Access Compliance Report Public Rights-of-Way (Curb Ramps)

Main Street: STARLIGHT_RIDGE Cross Street: MEANDERING_TRAIL Location: SE

ADA ID: RPRK211018181311 Ramp Type: Type 1 - Perpendicular Diagonal Initial Pass/Fail: Fail Overall Compliance: No Severity Score: 2

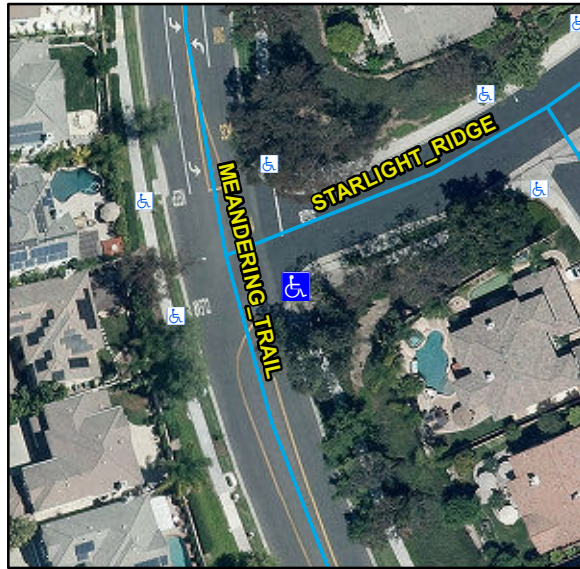
R304.2.2, R204.3, R304.5.3, STD 1115

Compliance	Description	Data	Compliance	Description	Data
N/A	Ramp Length (in)	88	N/A	Flare Type LT	
Yes	Ramp Width (in)	48			N/A
Yes	Ramp Run Slope (%)	7.4	N/A	Flare Slope LT (%)	N/A
No	Ramp Cross Slope (%)	3.3	N/A	Flare Traversable LT	N/A
N/A	Landing Present	N/A	N/A	Flare Type RT	
N/A	Landing Length (in)	N/A			N/A
N/A	Landing Width (in)	N/A	N/A	Flare Slope RT (%)	N/A
N/A	Landing Run Slope (%)	N/A	N/A	Flare Traversable RT	N/A
N/A	Landing Cross Slope (%)	N/A	N/A	DWS Provided	N/A
N/A	Landing Movement Obstructed?	N/A	N/A	DWS Contrast	N/A
	Landing Movement Type	N/A	N/A	DWS Length (in)	N/A
N/A	Landing Shared	N/A	N/A	DWS Full Width	N/A
N/A	Clear Space	Yes	N/A	DWS Offset Left (in)	N/A
N/A	Clear Space To Crosswalk (in)	N/A	N/A	DWS Offset Right (in)	N/A
N/A	Marked Crosswalk 1	No	N/A	Marked Crosswalk 2	No
	Crossing 1 Direction	N		Crossing 2 Direction	W
	Marked Crosswalk 1 Width (in)	N/A		Marked Crosswalk 2 Width (in)	N/A

N/A	Ramp Inside Crosswalk 1	N/A	Yes	Ramp Inside Crosswalk 2	N/A
	Crossing 1 Slope (%)	4.2		Crossing 2 Slope (%)	1.9
	Crossing 1 Cross Slope (%)	3.6		Crossing 2 Cross Slope (%)	3
N/A	Gutter Ponding	N/A	No	Curb Slope	8.3
Yes	Gutter Lip Height (in)	0		Road Run Slope (%)	3.8
N/A	Gutter Run Slope (%)	N/A		Road Cross Slope (%)	4
N/A	Gutter Cross Slope (%)	N/A			
Yes	Overall Surface Condition: Acceptable		No	Perp Joint Present	No
	Cross Gutter Present?	No		Spandrel Present?	No
	Replace Cross Gutter?	N/A		Replace Spandrel?	N/A

Remove & Replace Curb Ramp With Two New Directional Ramps or Equivalent.
